AS-CONSTRUCTED

ROAD AND STORM DRAINAGE CONSTRUCTION PLANS

WEST VILLAGE
RIVER CROSSING

CITY OF MILL CREEK
WASHINGTON

PRIVATE OFFSITE CONVEYANCE SYSTEM PLAN

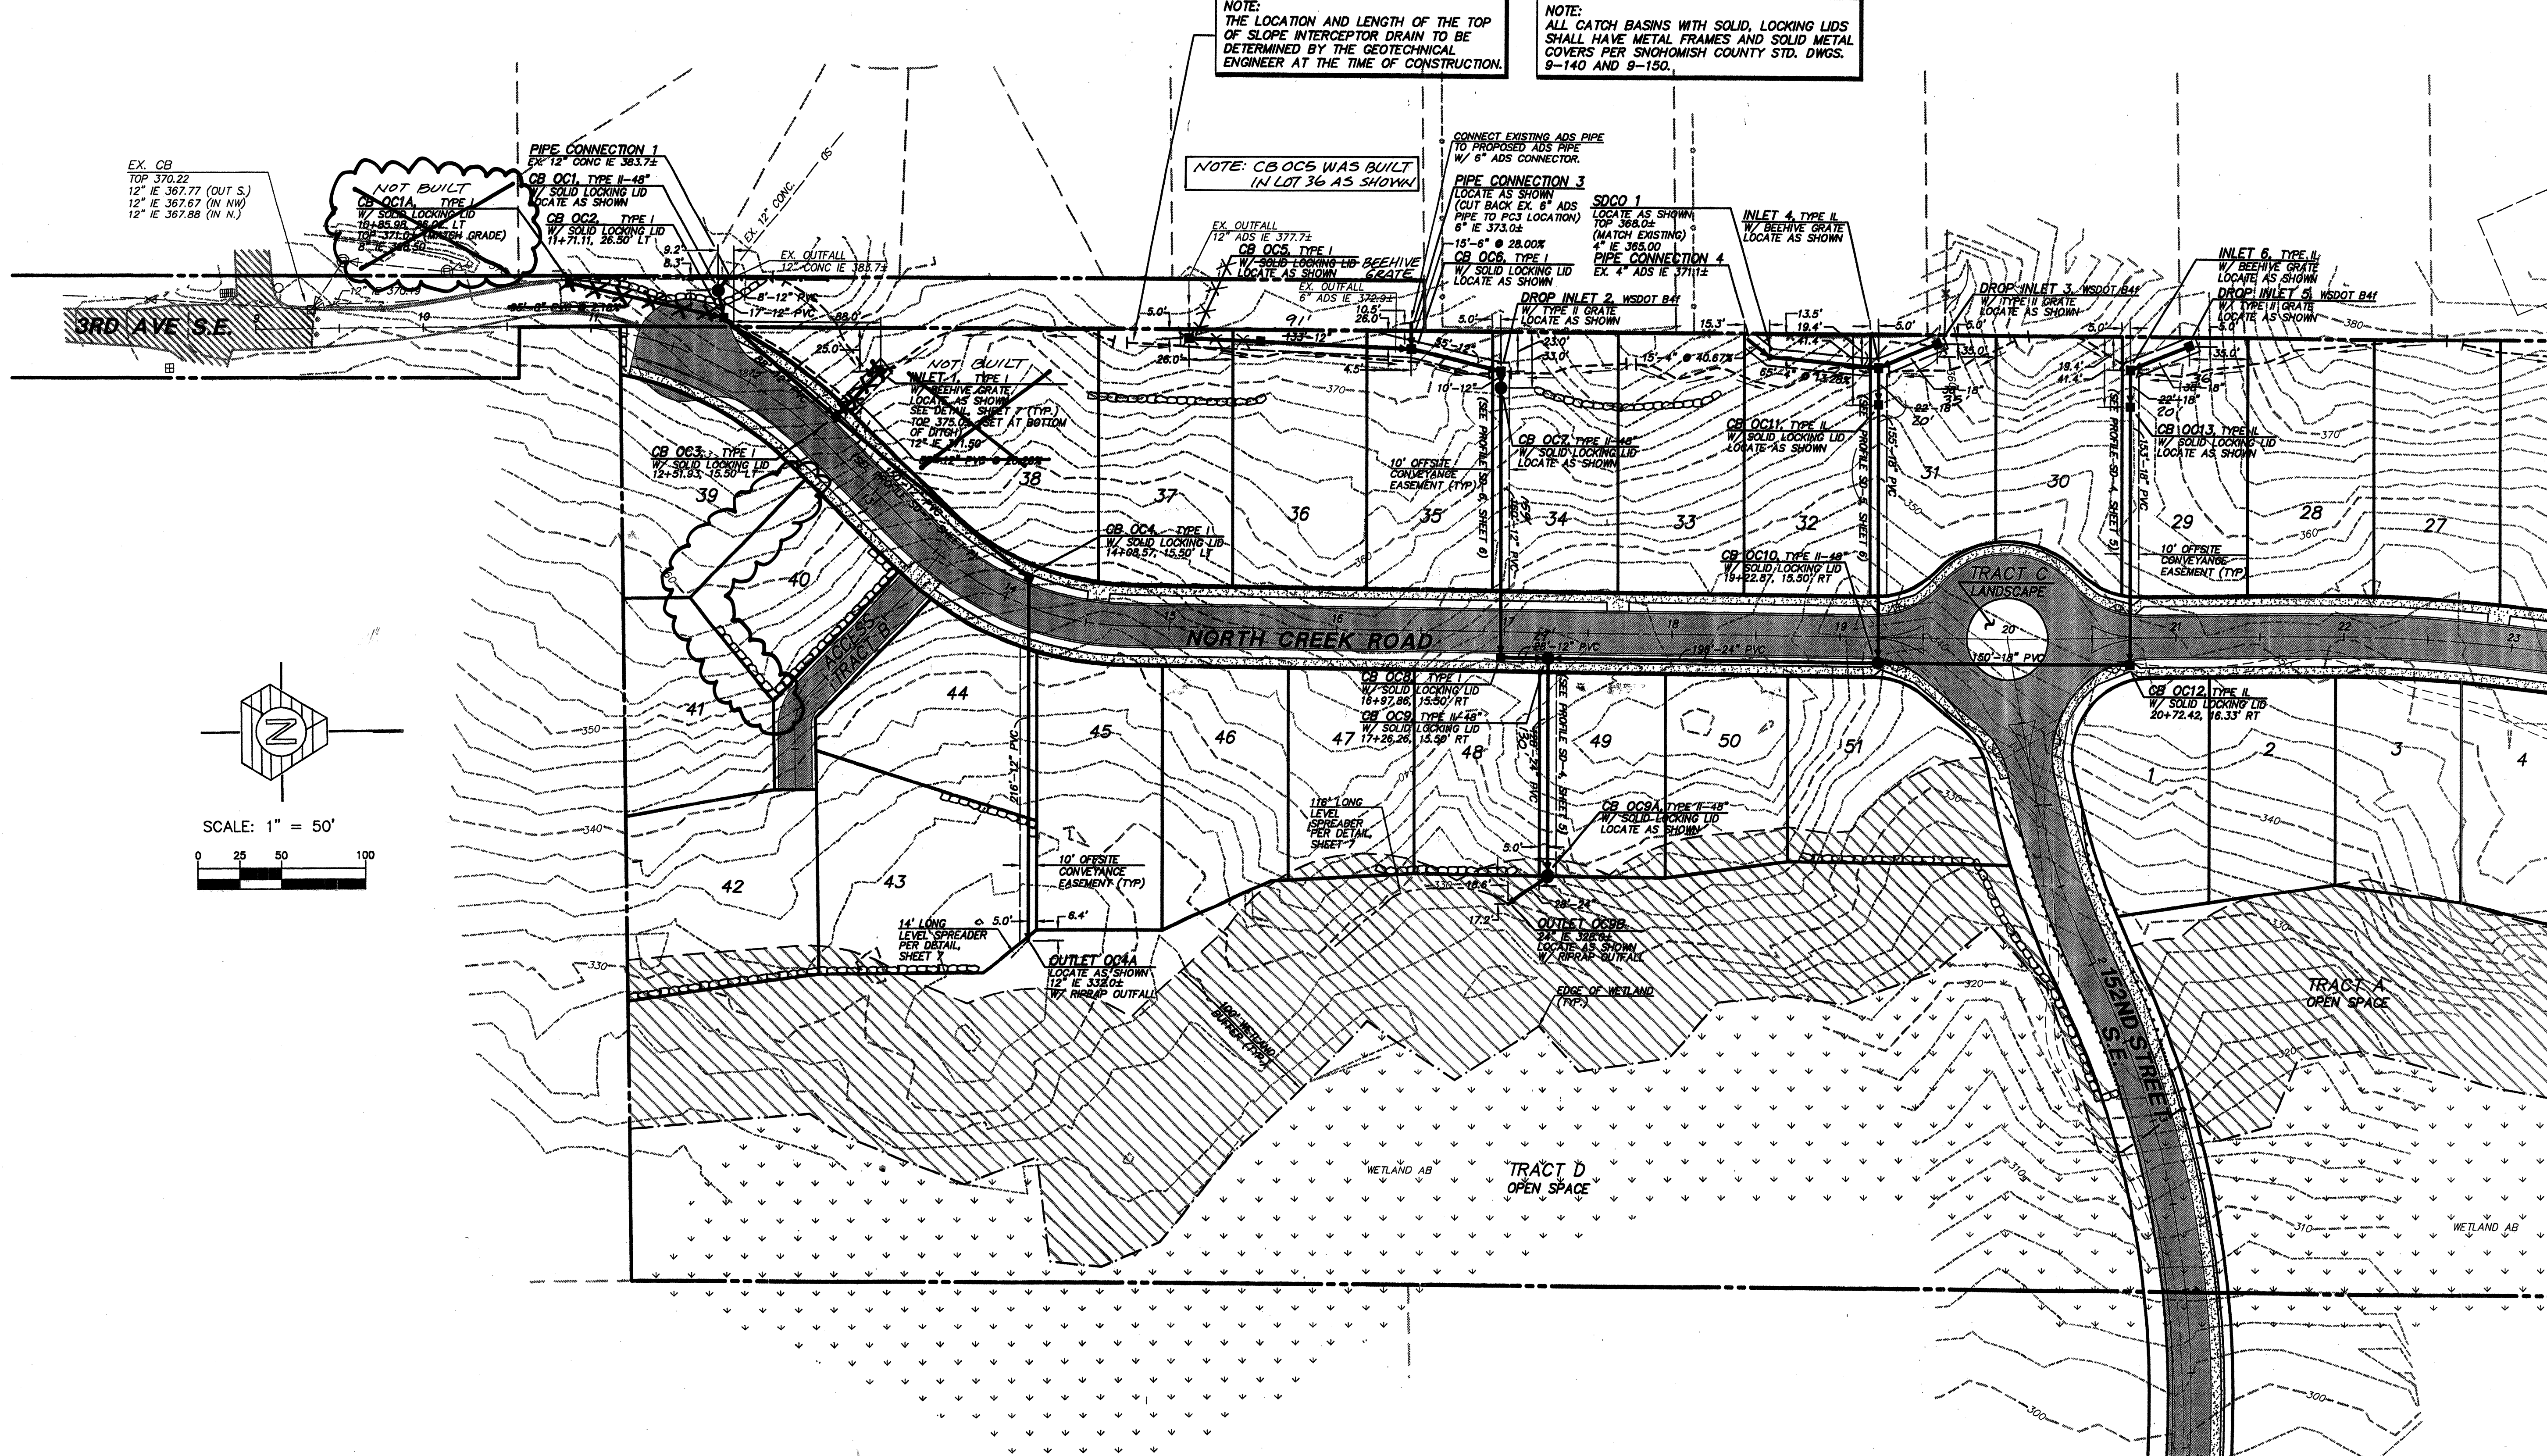
NOTE: CB OCS WAS BUILT
IN LOT 36 AS SHOWN

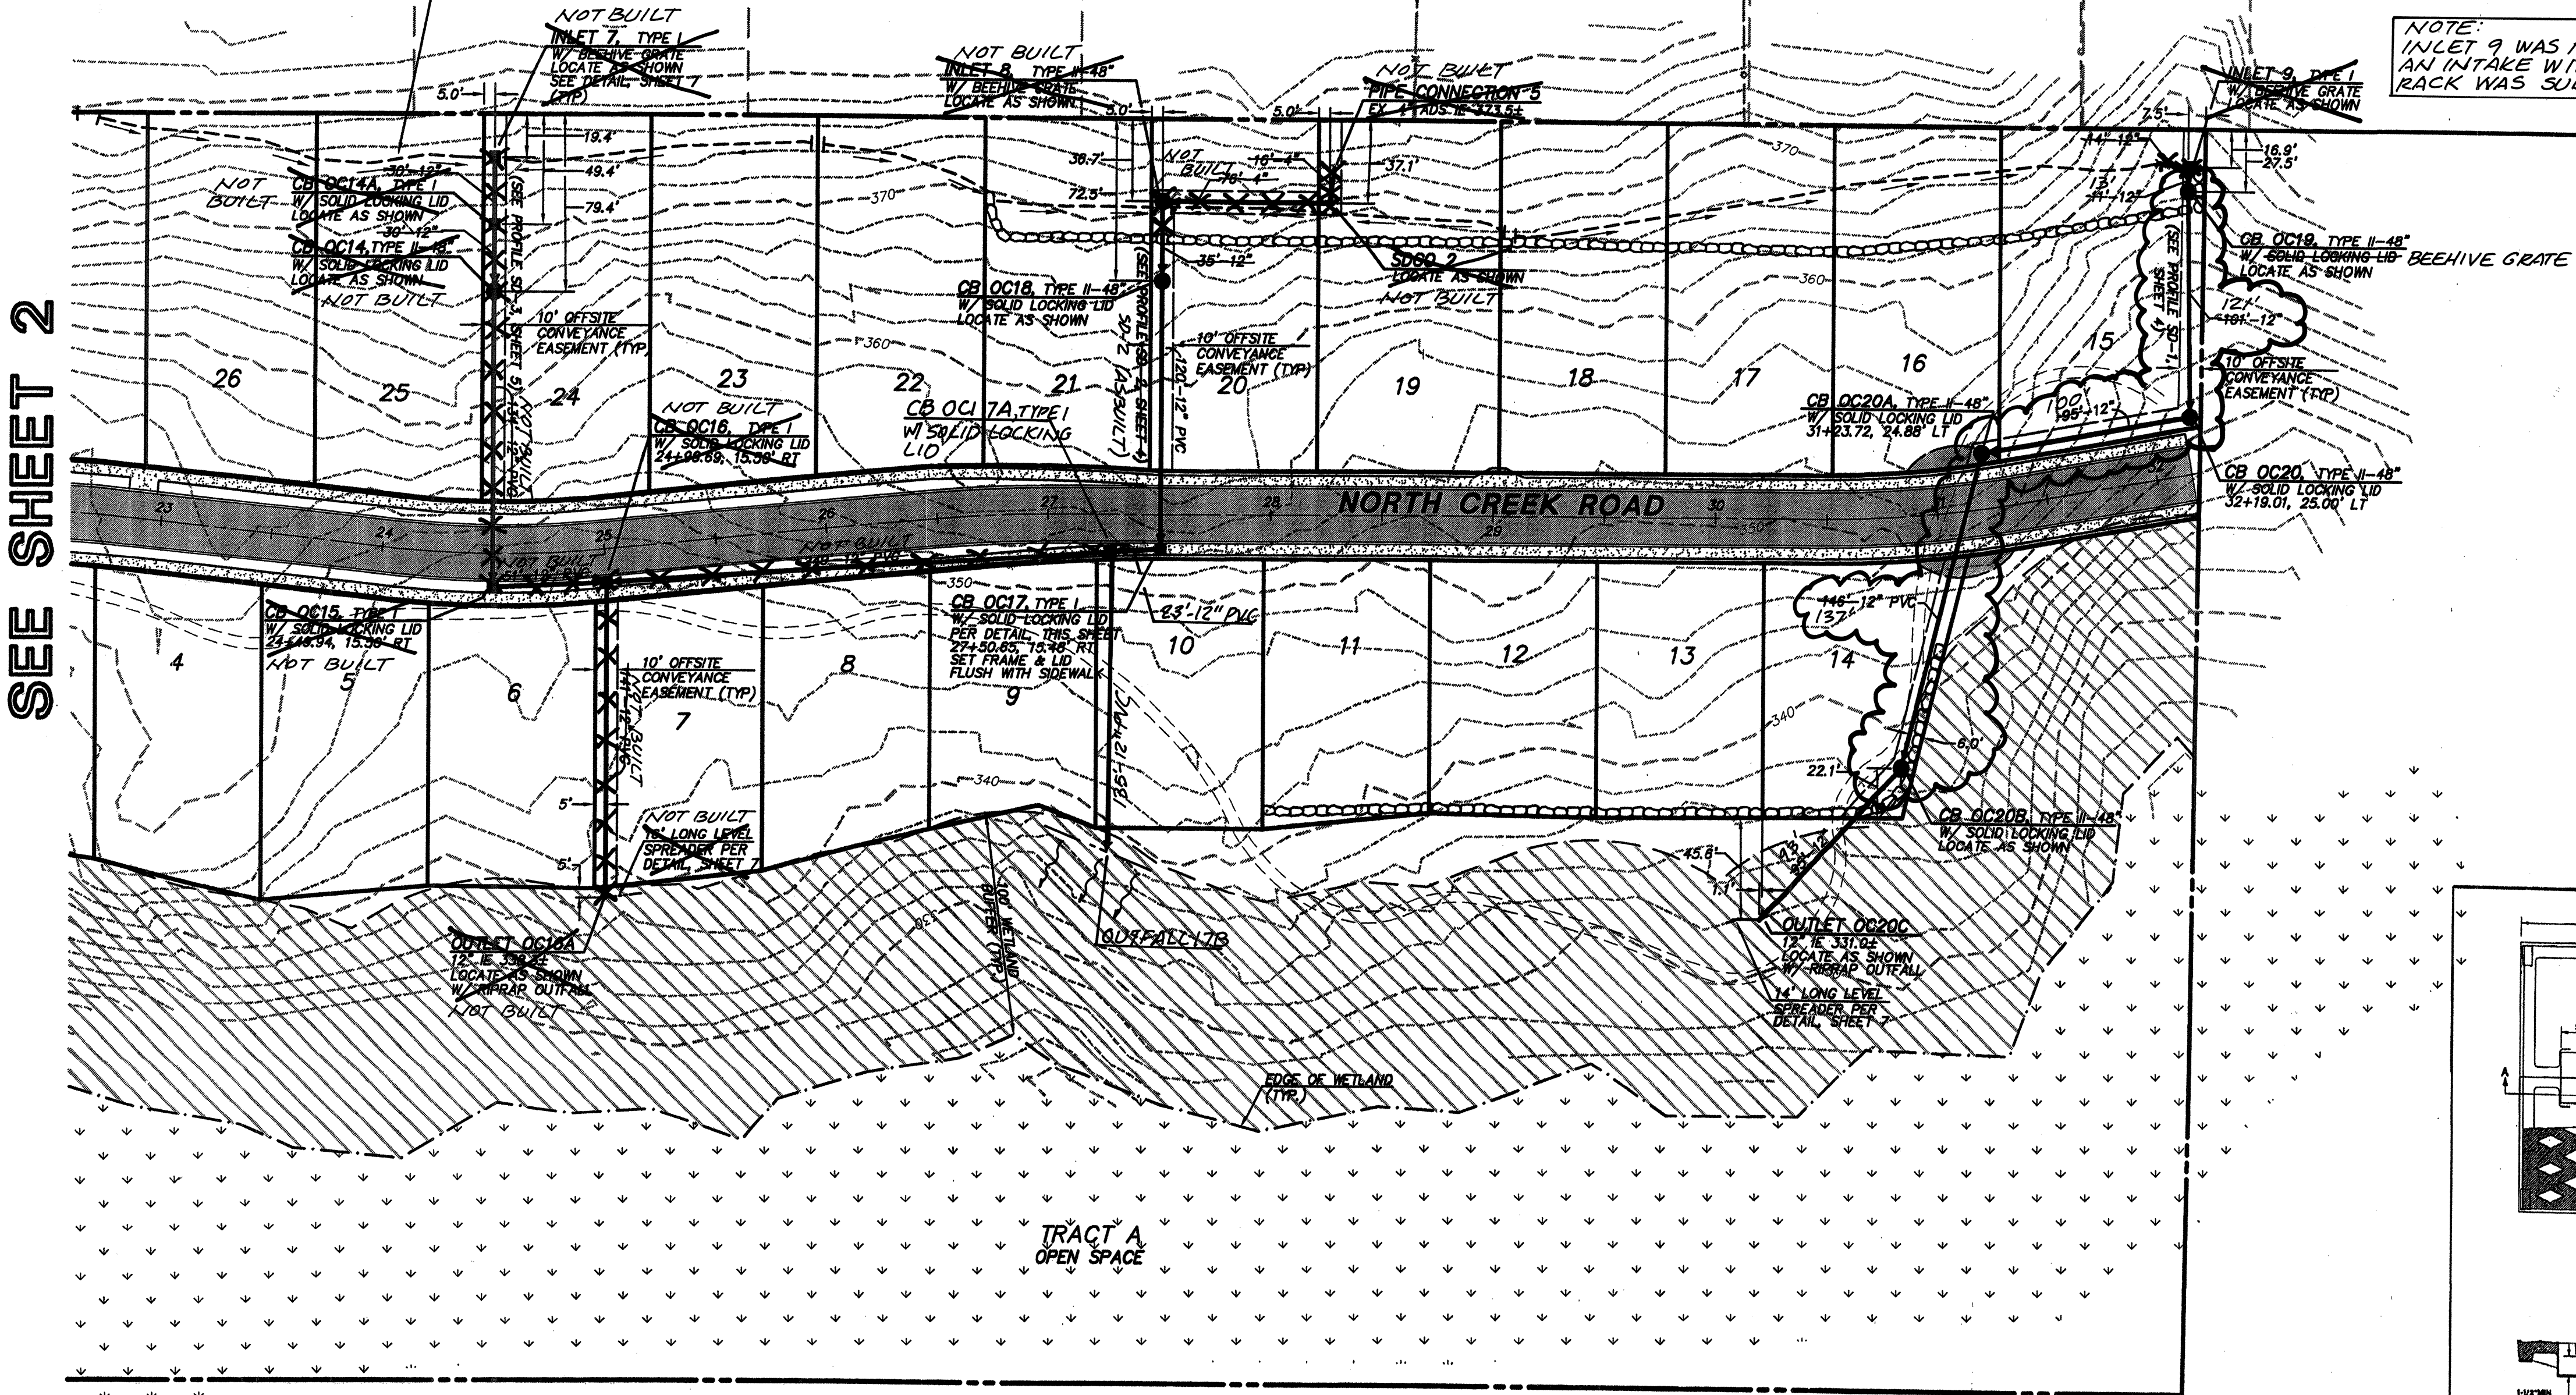
NOTE:
INLET 9 WAS NOT BUILT. AN INTAKE WITH TRASH-RACK WAS SUBSTITUTED.
